APPLICATION NO.	FILING DATE	FIRST NAMED INVENTOR	ATTORNEY DOCKET NO.	CONFIRMATION NO.
10/770,442	02/04/2004	Thomas Muller	P24853	3367
7055	7590	05/11/2006	EXAMINER	
GREENBLUM & BERNSTEIN, P.L.C. 1950 ROLAND CLARKE PLACE RESTON, VA 20191			HESS, DOUGLAS A	
			ART UNIT	PAPER NUMBER
			3651

Office Action Summary	Application No.	Applicant(s)	
	10/770,442	MULLER, THOMAS	
	Examiner Douglas A. Hess	Art Unit 3651

DETAILED ACTION

FIG. I Multi Layer

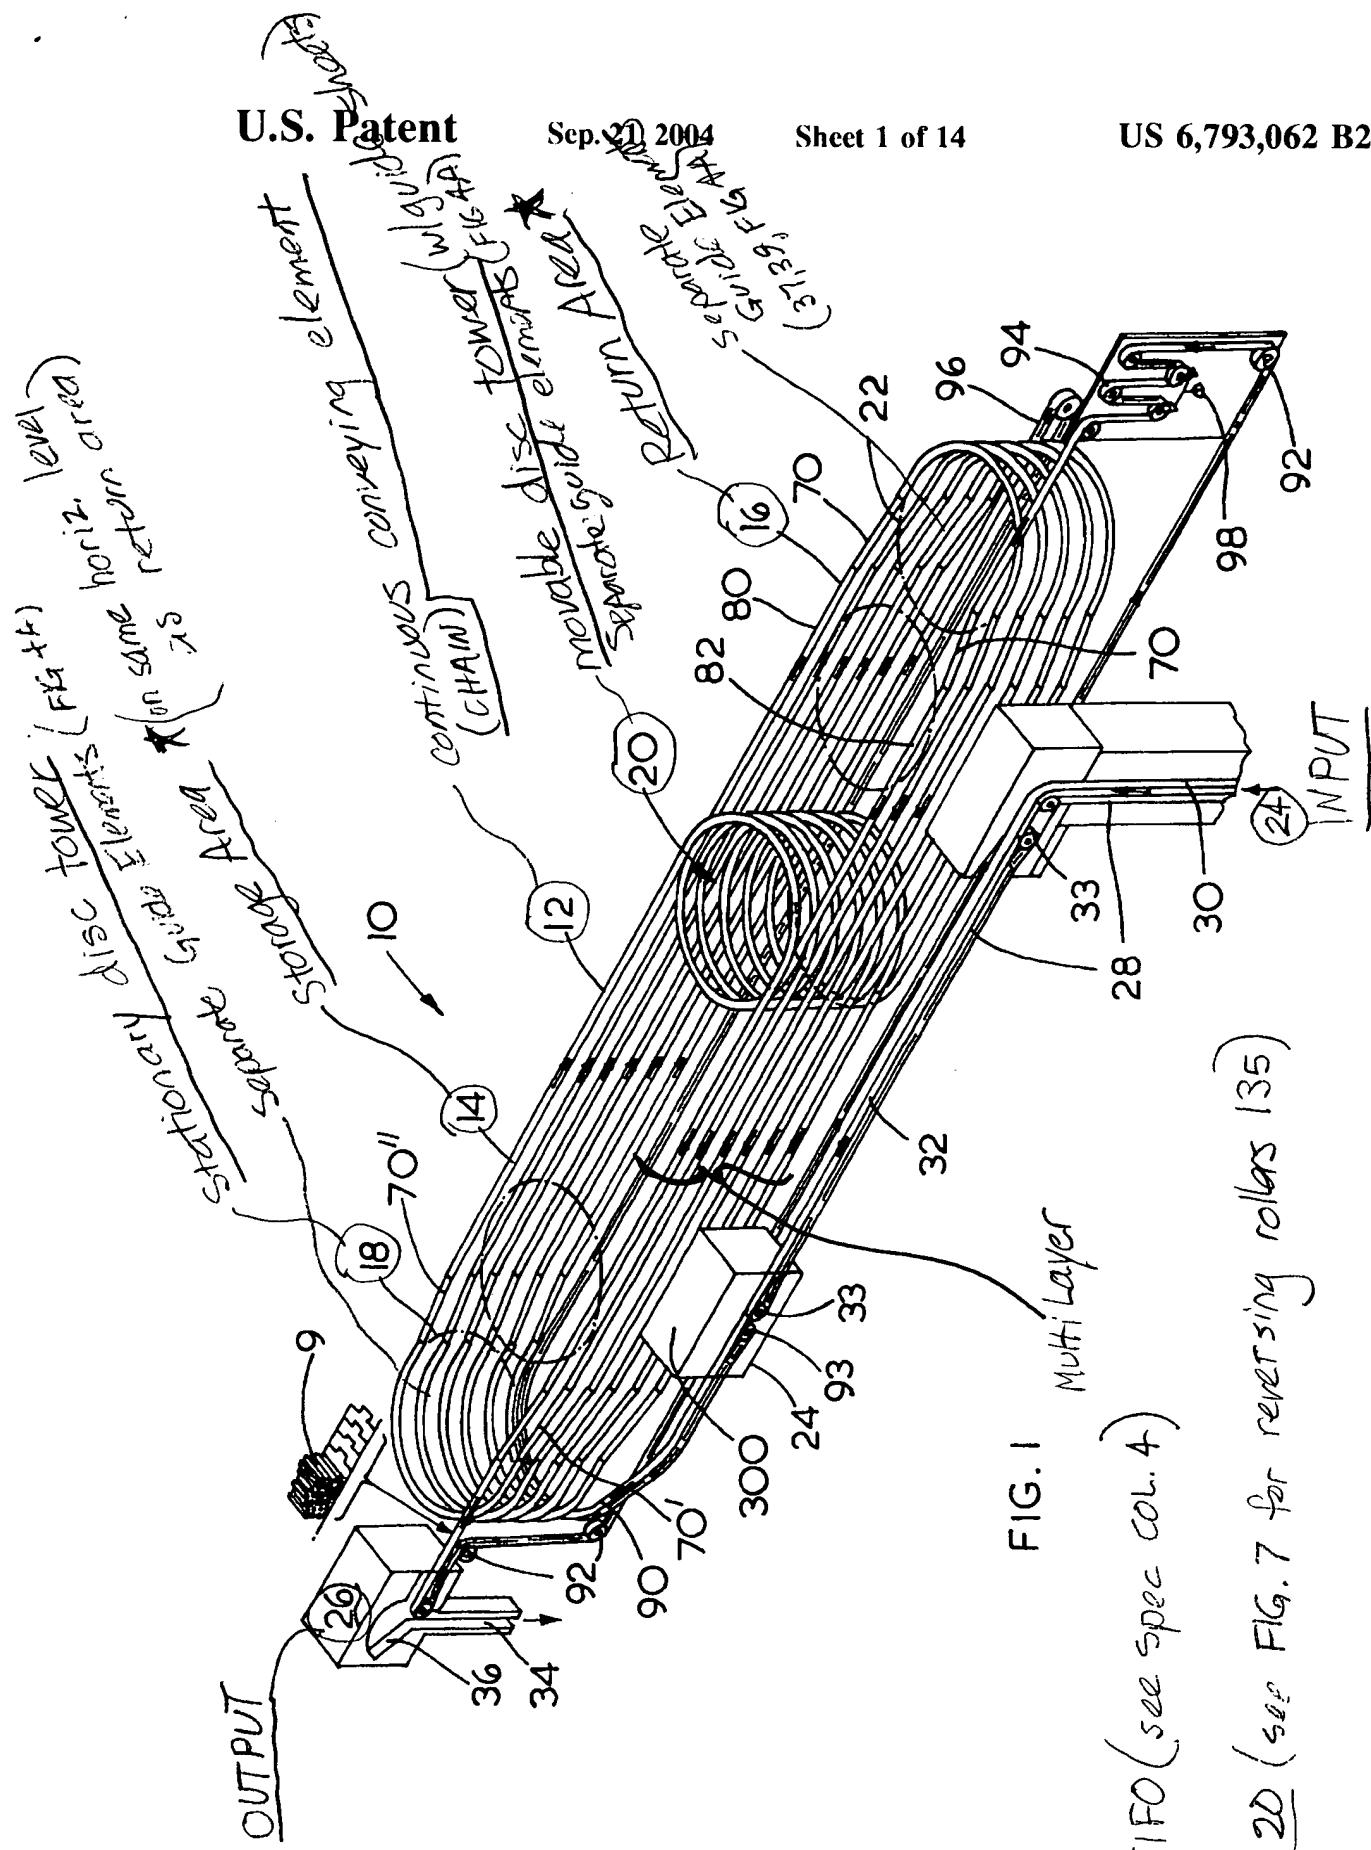
See the attached marked up drawing figure 1 of Hammock et al. depicting the claimed features.

CLAIM 20 (see FIG. 7 for reversing rollers 135)
